AGENDA
Hailey Planning and Zoning Commission
Monday, May 6, 2024
5:30 p.m.

To: Hailey Planning and Zoning Commission

Staff Report
Hailey Planning and Zoning Commission
Regular Meeting of May 6, 2024

DRAWING TITLE
SITE PLAN

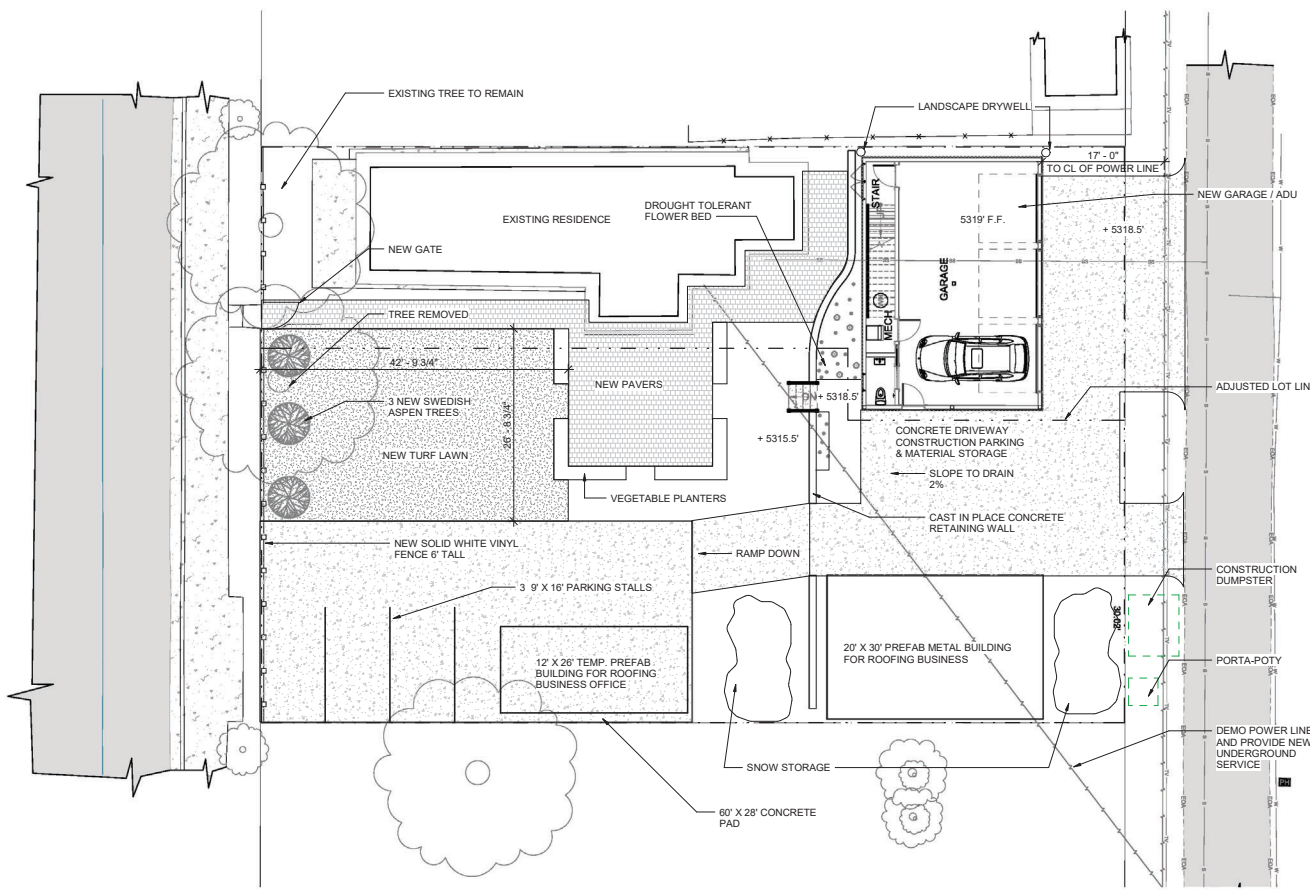
<i>three (3) additional uncovered parking stalls for the southwest corner of the property, Staff would like to highlight the parking area siting requirements noted in Hailey Municipal Code Section 17.09.020.01, and the subsequent Condition of Approval, Condition “I”, stated in this Staff Report. The Applicant should take great care in ensuring that pedestrian safety is upheld as site planning evolves.</i>
<input checked="" type="checkbox"/>	<input type="checkbox"/>	<input type="checkbox"/>	17.06.090(C)4	Guideline: The visual impacts of on-site parking visible from the street shall be minimized.
			<i>Staff Comments</i>	<i>See Section 17.06.090(C)4 of this Staff Report for discussion of on-site parking considerations. Relocation of on-site parking, as currently proposed, will minimize the visual impact from the street.</i> <i>The proposed garage area will be accessed via the alley to the east of the site, with little to no visual impact on surrounding streets. A six foot (6') tall, white vinyl fence is proposed along the entirety of the property's Main Street frontage, which will shield the front of the site from the street.</i>

<ul style="list-style-type: none"> • Consideration given to the impacts on adjacent properties when planning snow storage areas.
			<i>Staff Comments</i>	<i>Snow storage areas are proposed in the southeastern corner of the property, on either side of a pre-fabricated metal storage building that will be constructed at a later date. No impacts to pedestrian routes, vision triangles, or adjacent properties are anticipated with the proposed snow storage plan.</i>
<input checked="" type="checkbox"/>	<input type="checkbox"/>	<input type="checkbox"/>	17.06.090(C)8	8. Existing Mature Trees and Landscaping
				Guideline: Existing mature trees shall be shown on the site plan, with notations regarding retention, removal or relocation. Unless shown to be infeasible, a site shall be carefully planned to incorporate existing mature trees on private property into the final design plan.
			<i>Staff Comments</i>	<i>There is one (1) existing tree identified onsite that is proposed to be retained, as well as one (1) existing tree identified onsite that is proposed to be removed. Three (3) new Swedish Aspen trees are proposed to be planted along the property’s western boundary, directly adjacent to Main Street and the proposed six foot (6’) white vinyl fence.</i>

- l) The Applicant shall reconfigure the proposed parking area and prefab metal building to meet Hailey Municipal Code standards for rear property siting of new onsite parking areas, consistent with Section 17.09.020.01.
- m) The Applicant shall provide additional area for onsite snow storage, totaling at least 25% of the site's hardscape area.
- n) The project shall be constructed in accordance with the Application or as modified by the Findings of Fact, Conclusions of Law, and Decision.

DRAWING TITLE
ELEVATIONS

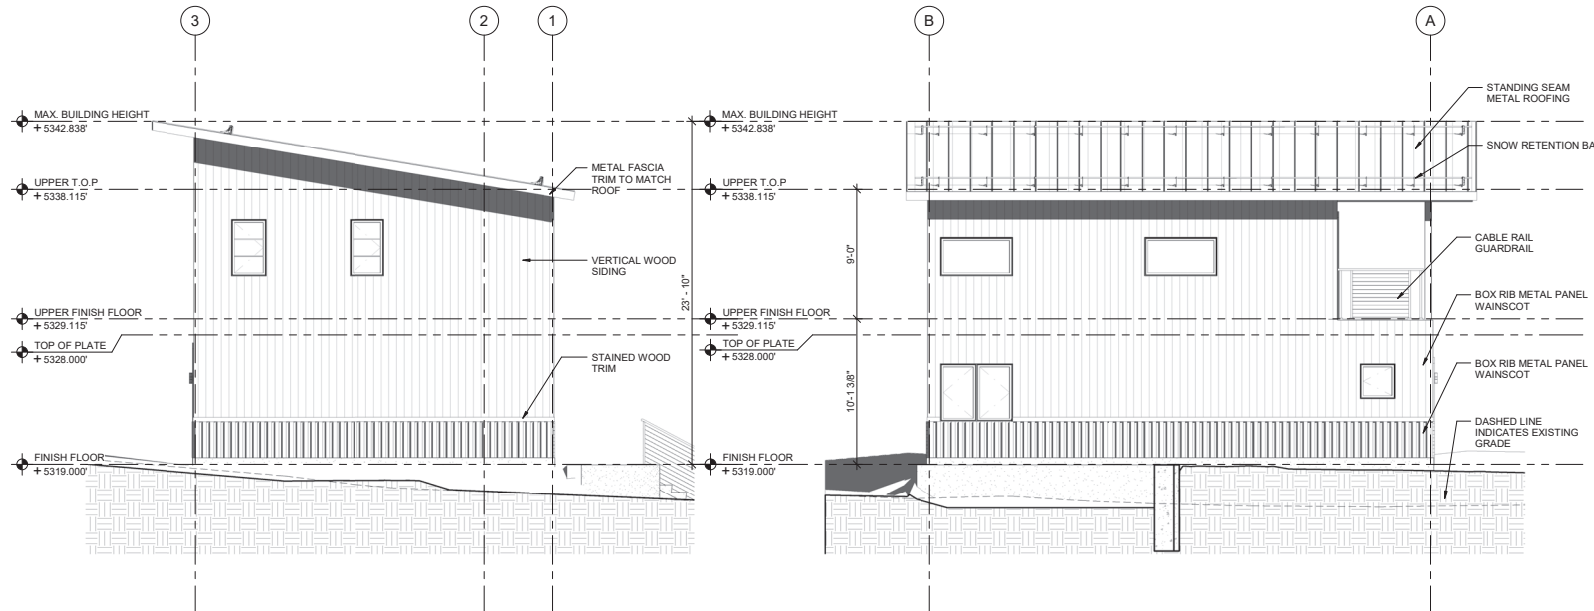
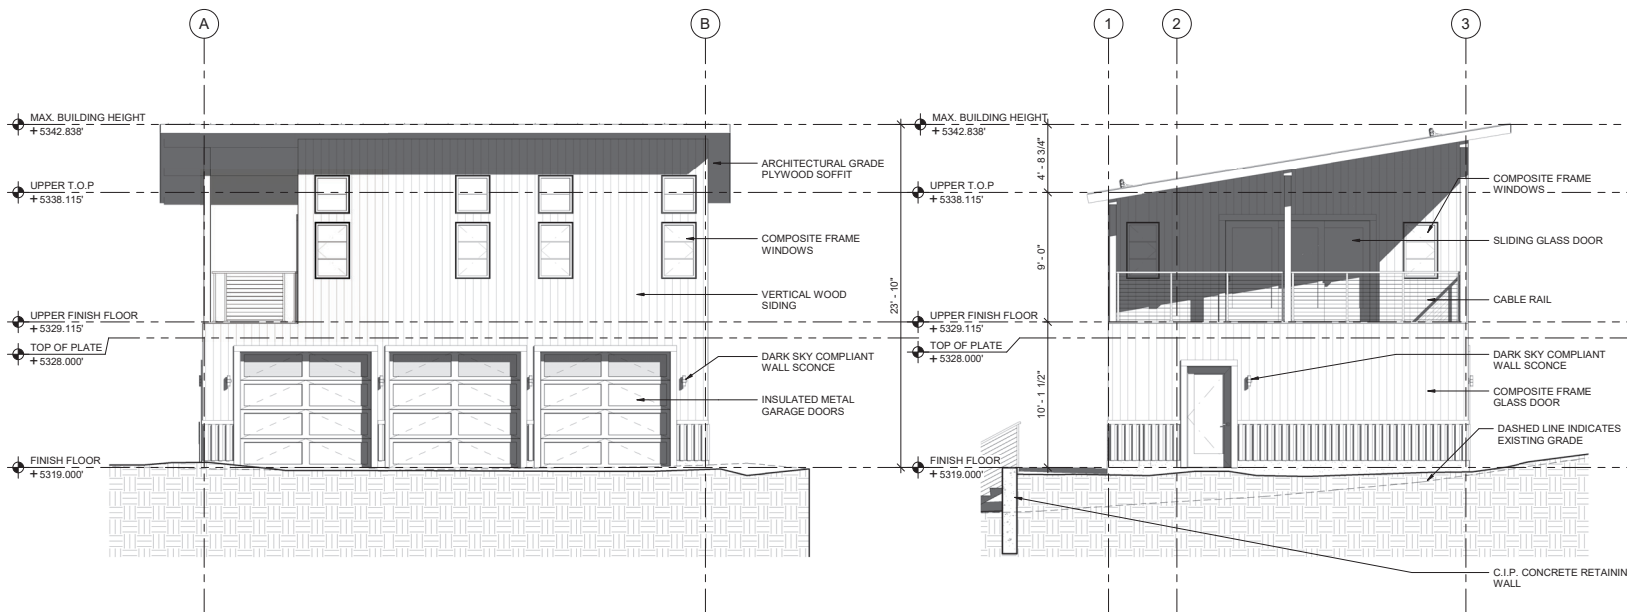
<i>Staff Comments</i>	<i>The structure will feature a low-pitch roof, with the shortest wall plane facing west/towards Main Street. This roof form will reduce the perceived scale of the garage/ADU from established front of the property (Main Street). The three (3) garage bay entrances will face the alley, diminishing these entrances to all surrounding traffic and uses, aside from activity in the alley itself.</i>
<input checked="" type="checkbox"/>	<input type="checkbox"/>	<input type="checkbox"/>	17.06.090(C)3d	<p>Guideline: Roof pitch and style shall be designed to meet snow storage needs for the site.</p> <ul style="list-style-type: none"> • Roof pitch materials and style shall retain snow on the roof, or allow snow to shed safely onto the property, and away from pedestrian travel areas. • Designs should avoid locating drip lines over key pedestrian routes. • Where setbacks are less than ten feet, special attention shall be given to the roof form to ensure that snow does not shed onto adjacent properties.

Staff Comments	<p><i>Each wall plane of the proposed garage/ADU incorporates at least one change in material and/or color, including corrugated metal siding, wood trim and detailing, and off-white vertical wood siding.</i></p> <p><i>However, the Commission may refer to Staff comments provided in Section 17.06.090(C)3e of this Staff Report, which discusses a level of concern with large, unbroken wall planes on the north and west building elevation, specifically. Staff believe that additional material/color detailing on these elevations could benefit the overall project design and better complement the surrounding neighborhood.</i></p>
<input checked="" type="checkbox"/>	<input type="checkbox"/>	<input type="checkbox"/>	17.06.090(C)3i	<p>i. Ornamentation and Architectural Detailing</p> <p>Guideline: Architectural detailing shall be incorporated into the front wall plane of buildings.</p> <p>Staff Comments</p> <p><i>The Applicant’s property hosts an existing single-family residence with its entrance facing west, towards Main Street. The proposed garage/ADU will off pedestrian access on its south elevation, and garage/vehicular access from the alley and facing east. The pedestrian entrance elevation (south-facing) offers substantial architectural detailing, including changes in materials and colors, a single-pitch shed roof, steel cable railings with wood capping for the second-floor outdoor deck space, and wooden post and beam features.</i></p> <p><i>The garage/ADU’s Main Street (west)-facing elevation features a degree of architectural detailing, including changes in color and materials, although as Staff has noted previously in this Staff Report, additional architectural features on the west elevation may serve to break up the large wall plane and add visual interest to this wall plane.</i></p>
